LIST OF ANNEXES

Subject: **Accident of LUXAIR LGL9642, Fokker 50, 6th November 2002**

SUBJECT: LANDING GEAR SKID CONTROL SYSTEM - CONTROL UNIT REWORK INSTRUCTIONS

AIRWORTHINESS DIRECTIVE**AD : LUX-2002-001**Grand-Duché de Luxembourg
Ministère des Transports
Direction de l'Aviation Civile
(DAC)

Modification of Wheel Control Board to 6004384-2/5R90-829
Figure 1 (Sheet 1 of 2)

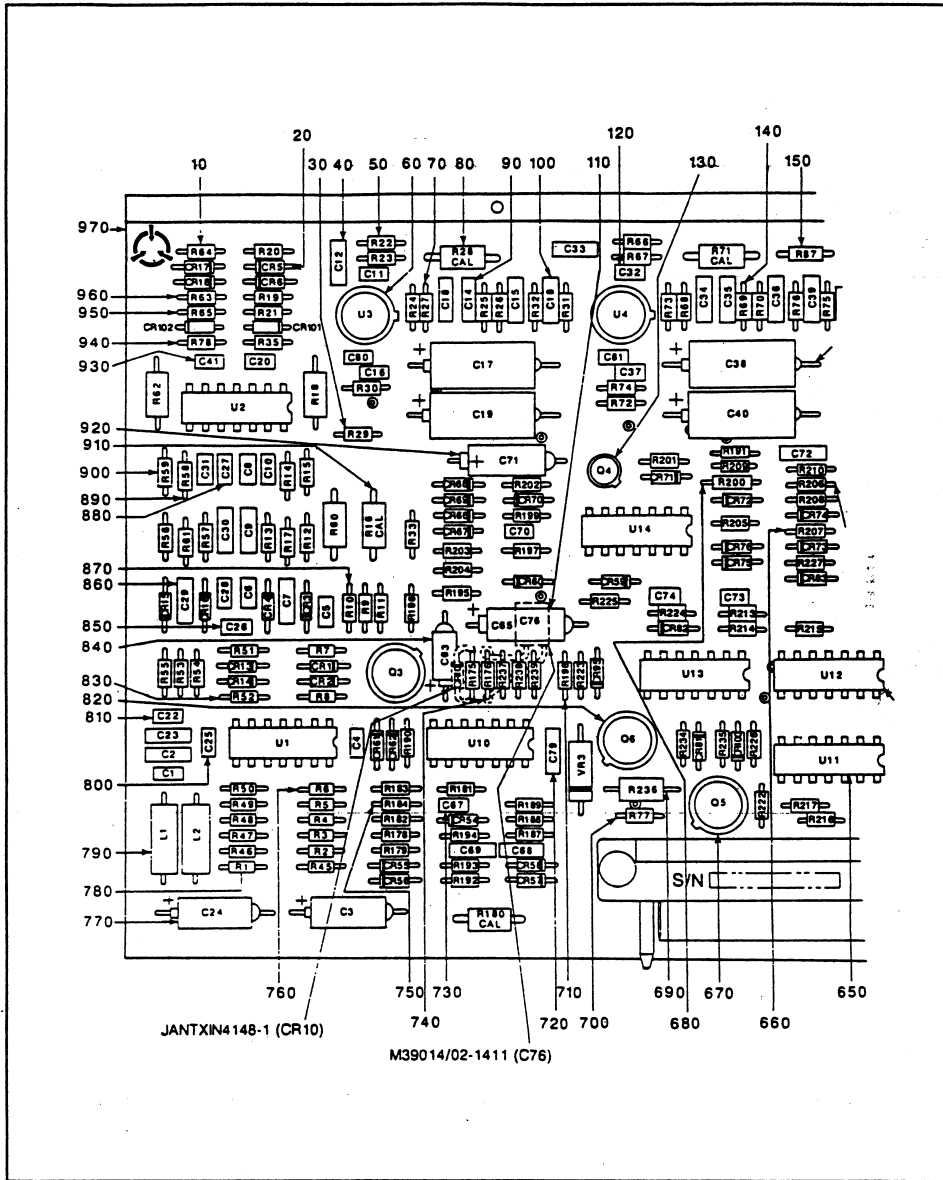
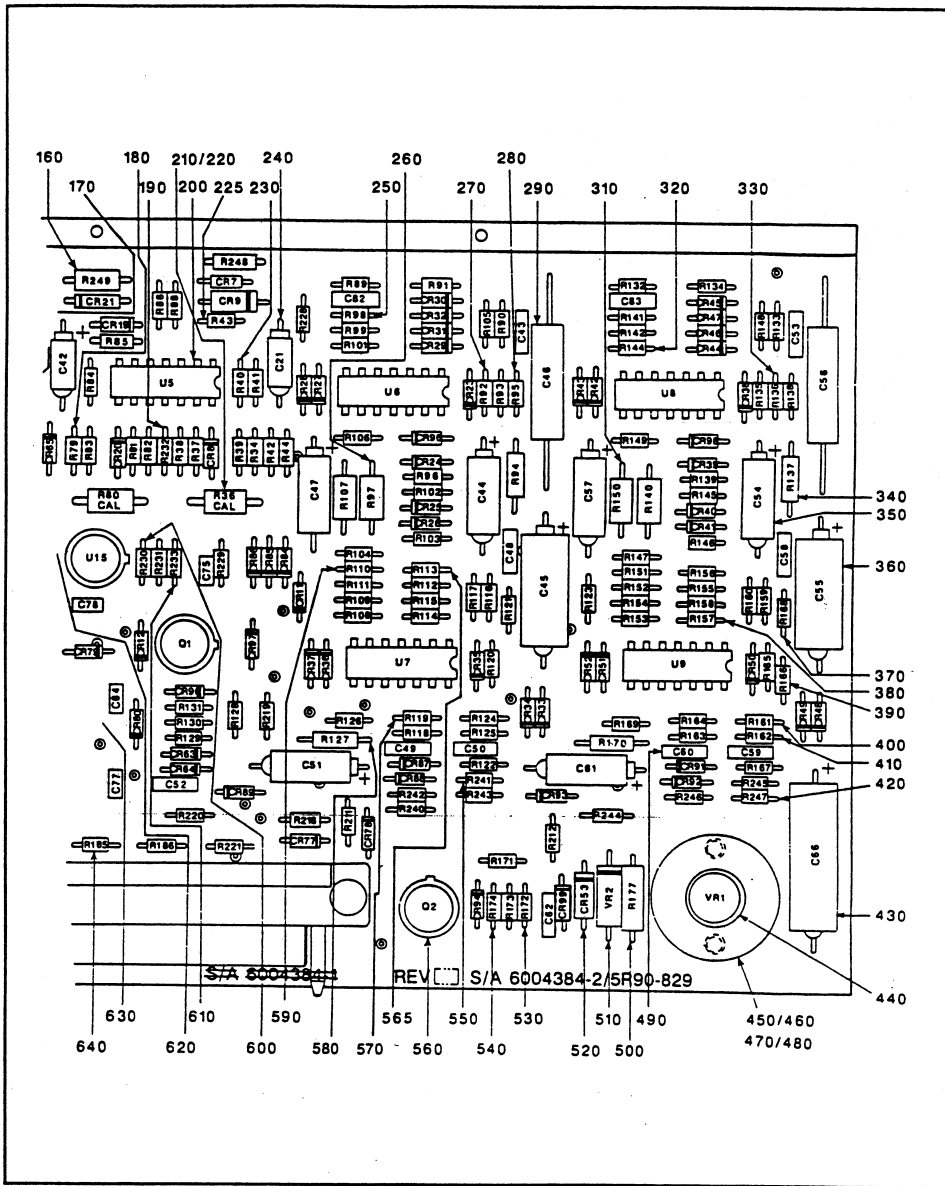
- (1) Rework Control Board Subassembly 6004125 into 6004125-1 as follows (See Figure 1):
 - (a) Install Capacitor M39014/02-1411 (C76) and Diode JANTXIN4148-1 (CR10) on the non-component side of board as shown in Figure 1.

- 1 Solder each component to board and trim ends.
- 2 When installing a new component, maintain 0.03 inch (0,76 mm) minimum space between the component and the surface of the board.

- (1) Board identification is located adjacent to the board connector as shown in Figure 1.
- (2) On each control board, cross out but do not obliterate existing identification.
- (3) Reidentify board as part number S/A 6004384-2/5R90-829 in 0.10 inch (2,54 mm) high characters, using a contrasting color epoxy marking ink, Hysol Wornowink, Series M.

The Automatic Flight Idle Stop
Figure 1

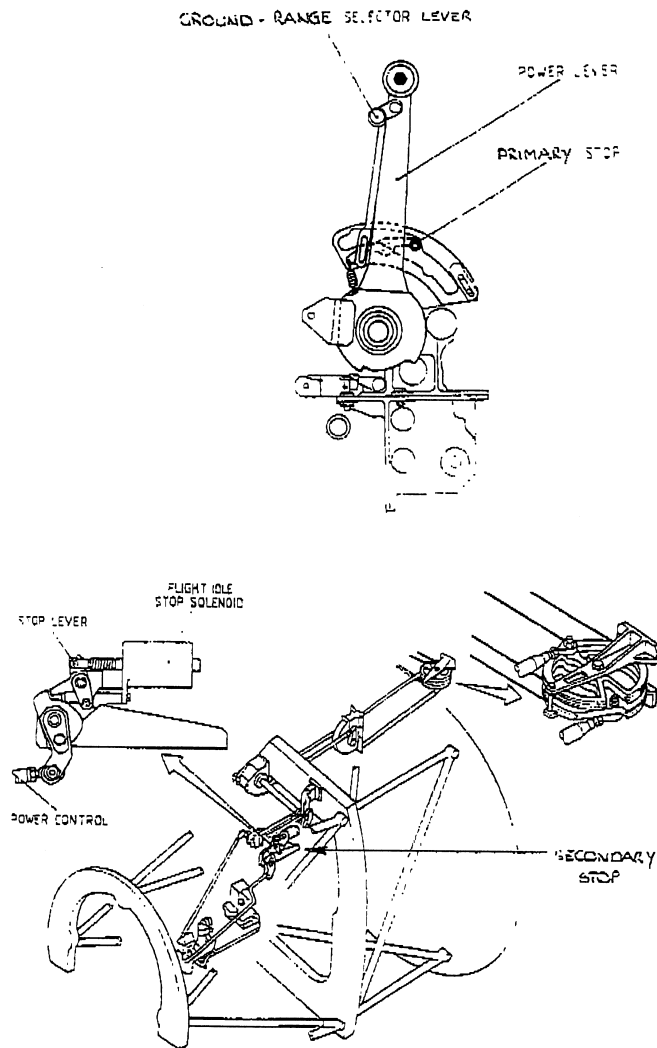
It has been reported that handling of the ground-range selector-levers occurs during flight, e.g. when the hand of the pilot holds the selector levers during turbulent weather conditions. This may result in the situation that the power levers pass the primary stop and now rest against the secondary stop. When the engine controls are incorrectly adjusted this may result in a propeller RPM/drag increase. When the power levers remain against the secondary stop during aircraft landing, it may not be possible to move the power levers into the Ground range due to the imposed friction.

The secondary or so called automatic flight-idle stop prevents inadvertent entering of the propeller into the Ground range during flight if the ground-range selector-levers are accidentally operated. The location of this secondary stop on the engine also ensures protection after a control cable failure.

However in-service experience revealed that the flight-idle stop solenoids may also be energized, during flight, for a period of 16 seconds under the following circumstances:

1. When both the LH and RH main landing gear uplock-switches are de-energized at the exactly the same time. Although considered to be remote, this may happen during each flight when the landing gear is selected down.
The occurrence of this phenomenon can be prevented with a skid control unit modification. This modification, when incorporated, changes the partnumber of the skid control unit from 6004125 into 6004125-1 and is covered by Service Bulletin Fo50-32-4 from the vendor Aircraft Braking Systems. This modification was incorporated into anti-skid unit s/n AUG92-117 and subsequent.

The Anti-Skid Control System
Figure 2

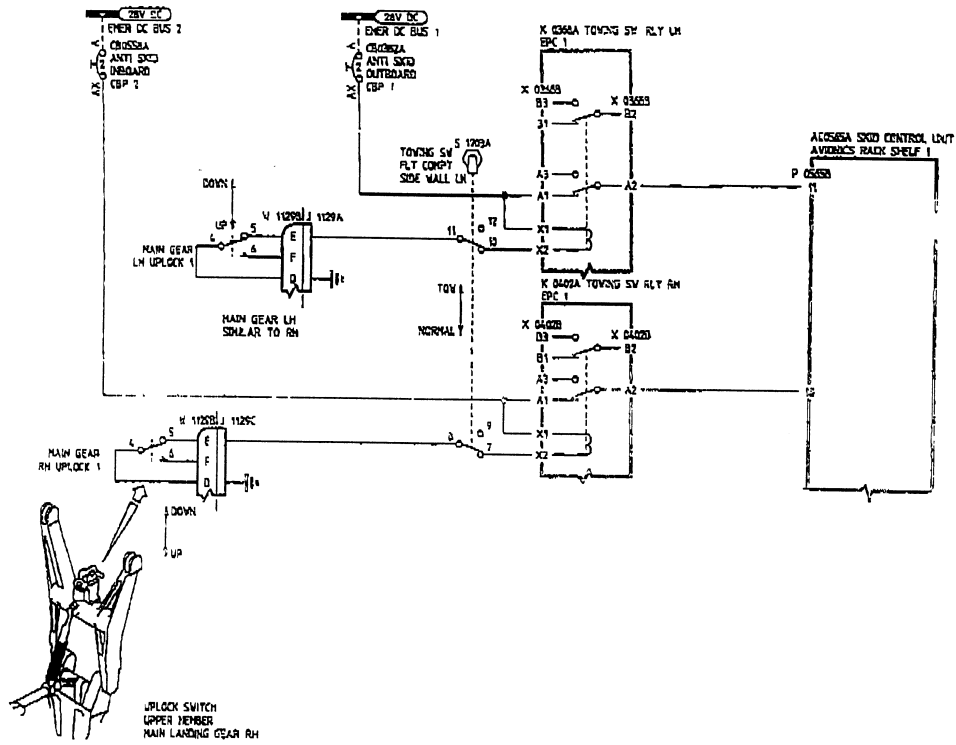
When the flight-idle stop solenoids (one on each engine) are energized, the lock-lever is withdrawn from the power levers. This makes it possible to retard the power levers into the Ground range after landing of the aircraft. During normal operation of the system, the solenoids will be energized after landing when one of the following input signals is available:

- Wheel speed-up signal (20 MPH) from the anti-skid control system
- Ground signal from the Ground/Flight relays.
